SUBJECT: REVIEW OF PRELIMINARY ACCIDENT SEQUENCE PRECURSOR ANALYSIS
OF EVENT AT OCONEE NUCLEAR STATION, UNIT 3

LER No. 287/97-003

Event Description: Two high-pressure injection pumps were damaged because of a low water level in the letdown storage tank

Licensee Comments

Fig. 2. Dominant core damage sequence for LER No. 287/97-003.

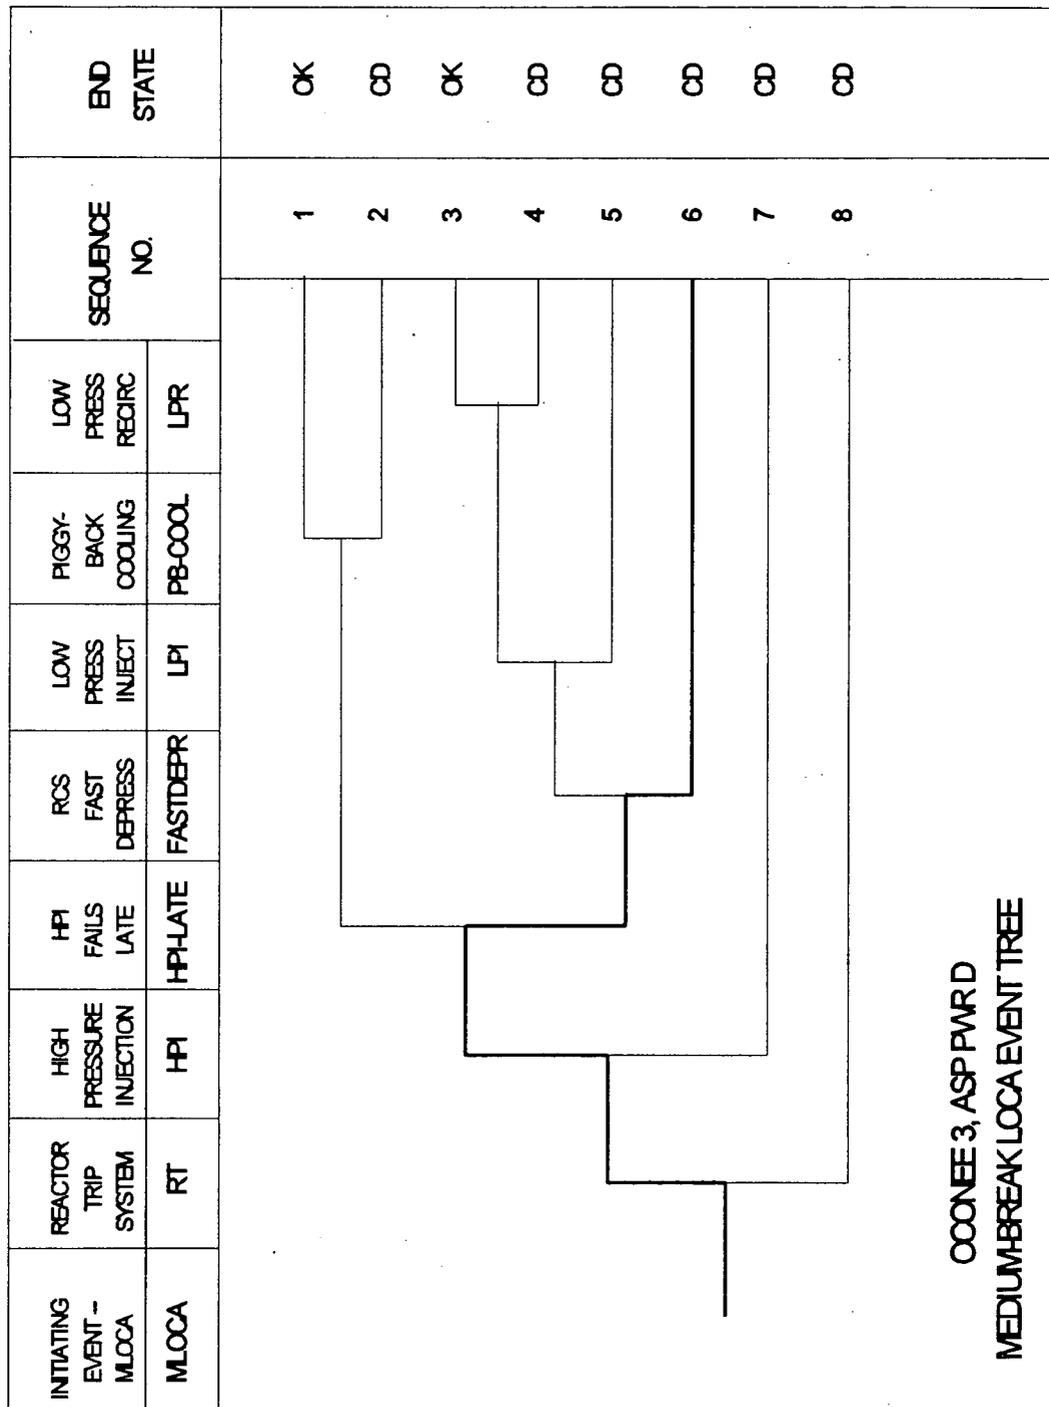
Comment 1c: Duke assumed that it would be possible to depressurize the primary system and initiate DHR using the LPI system for medium-size LOCAs. This was applied as a "recovery" event for cut sets where both steam generator cooling and the LPI system were available. The NRC did not take credit for this potential recovery.

Response 1c: The medium-break LOCA model has been revised to address the potential use of fast depressurization, LPI, and low-pressure recirculation if HPI were to fail late in the injection phase. This is consistent with recovery actions included in the Oconee Individual Plant Examination (IPE) report.
